# GRAND CANAL TWO-WAY CYCLE TRACK REVIEW

# RATHMINES ROAD (PORTOBELLO) TO GRAND CANAL STREET LOWER

1st July 2013

**Fig 2 - Section of route inspected and key bridge junctions**

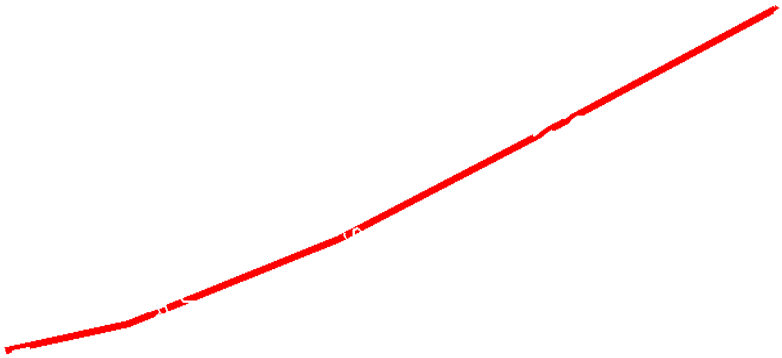
The section of the route inspected and the Bridge junctions monitored are shown in Fig 2 below, i.e. all junctions between Portobello Bridge and Lower Grand Canal Street Bridge.

**Fig 8 – Conflict Diagram**

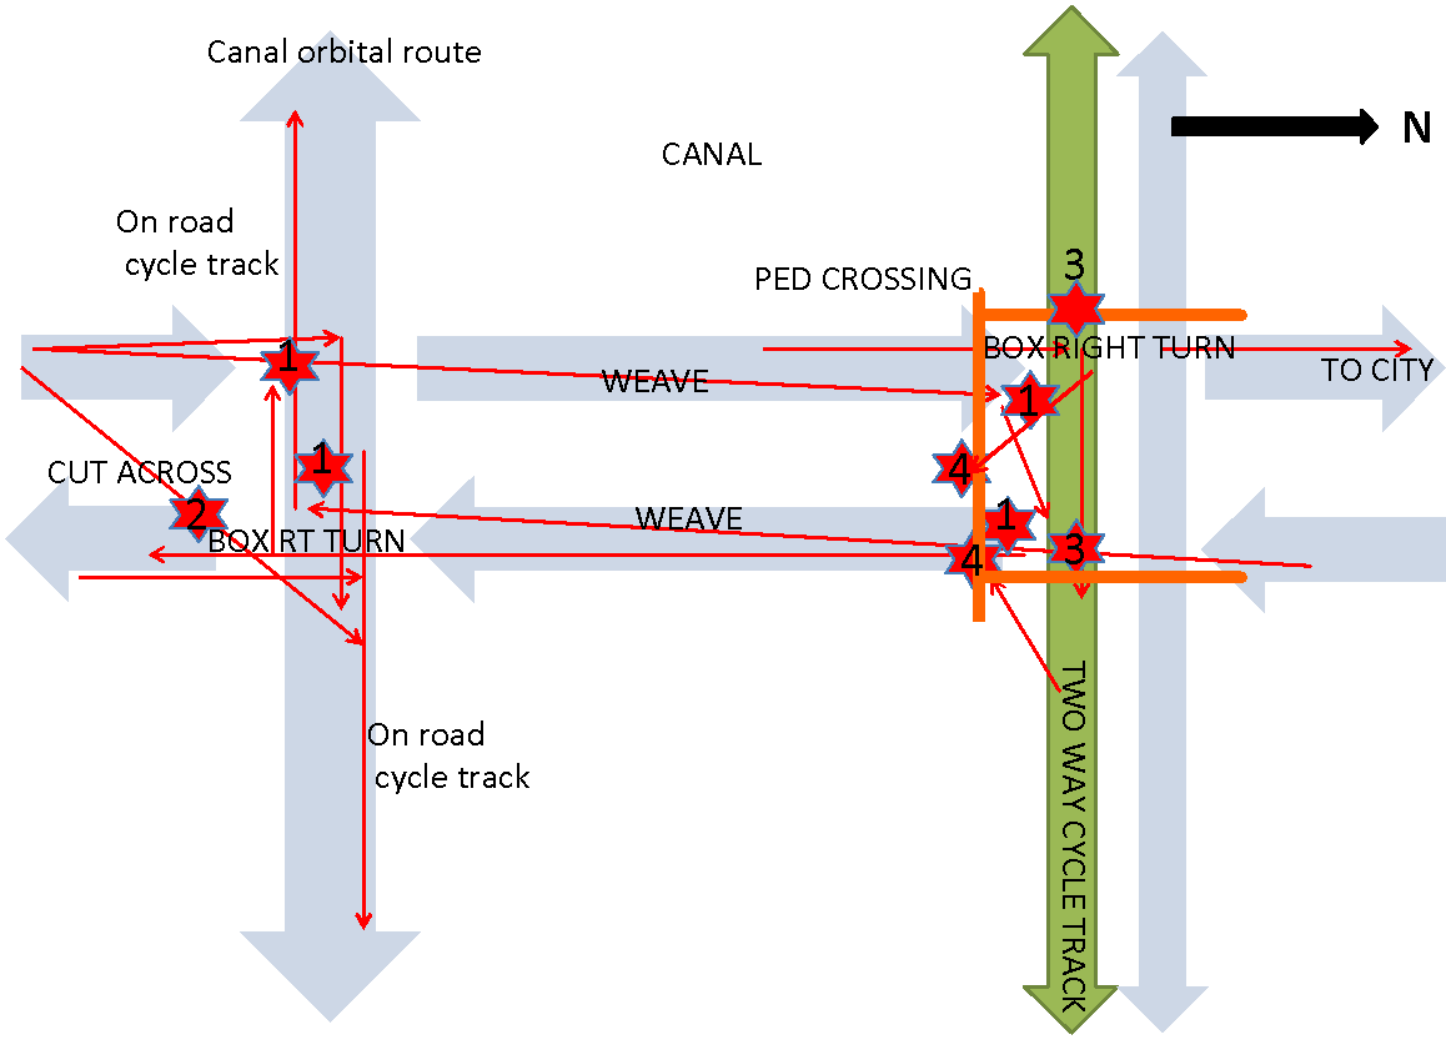
Figure 8 below identifies the potential conflicts observed. One is as a result of a cycle weaving maneuver to turn right into the cycle track, the other is a direct cut across the traffic lanes by a cyclist to access the cycle track from the footpath and the third is a pedestrian /cycle conflict at the signalized pedestrian/cycle crossings with pedestrian movements across the road and cyclists turning left and right to/from the cycle track.

| **Conflict Type (ref diagram 5.0)** | **Frequency (observed – to be validated)** | **Potential Outcome (e.g. v. serious, serious, minor..)** | **Risk** | **Design Solution / Mitigation** |
|---|---|---|---|---|
| **Veh/Cycle Conflict**<br><br>TYPE 1 :TURNING RIGHT FROM MAIN ROAD TO TWO WAY CYCLE TRACK<br>Cyclist weaving from extreme left to two-way facility on far right (fig 6)<br>or<br>taking stationary position mid bridge between two opposing traffic streams (fig 5) | **Very frequent** | **Serious** | **High** | **Encourage "left to go right: by creating Box Turn space** |

| **Veh/Cycle Conflict**<br><br>Type 2 – ESSENTIALLY SAME AS 1 ABOVE BUT USUALLY BY RISK AVERSE CYCLIST<br>cyclists cutting across into opposing traffic prior to bridge to access on road cycle track | **Infrequent** | **Serious** | **High** | **Encourage "left to go right" by creating Box Turn space** |
| **Cycle/Cycle Conflict**<br><br>Type 3: CYCLISTS BLOCKING ENTRANCE TO CYCLE TRACK- Cyclists stacking in both lanes of cycle facility, precluding cyclists from entering .. | **Frequent** | **Minor – due to low speeds** | **Low** | **Cyclists are not stacking correctly behind holding lines for signals or on the correct side. Holding lines should be moved forward and more stacking space created.** |
| **Ped/Cycle Conflict**<br>Type 4: PEDESTRIANS CROSSING BRIDGE ON "GREEN MAN" – Cyclists turn through crossing pedestrians (fig 9) | **Very frequent** | **Minor due to low speeds** | **Low** | **Not much can be done but the flashing amber lights help. Recommend changing to Toucan crossings for consistency** |

**Fig 13 – Create Space for Box Turn movements**

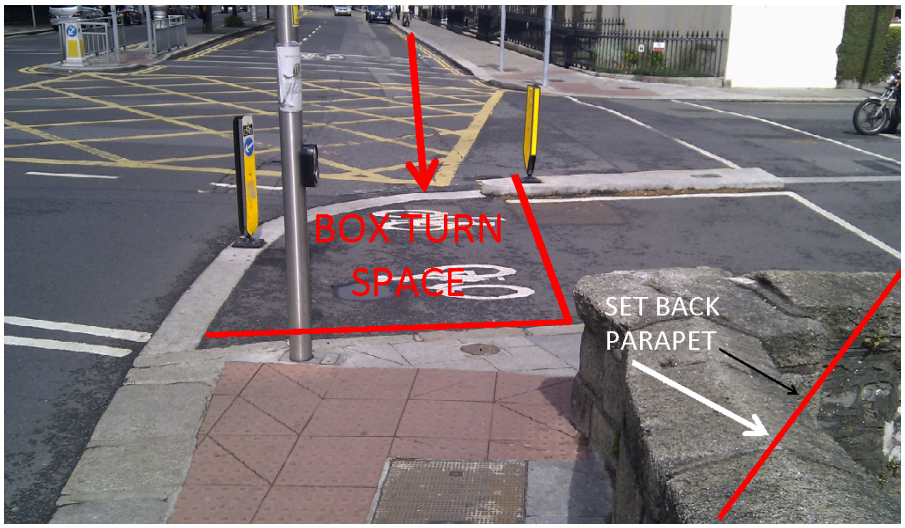
1. Create a "Box Turn" storage area for cyclists turning right into the Cycle Track. See Fig 13
2. Remove Advance Stop lines where Box turning is provided for, see Fig 14
3. Consider replacing the dedicated Cycle crossing signals with standard "Toucan" crossings for pedestrians and cyclists as is on the Lower Grand Canal Bridge junction. See Fig 12
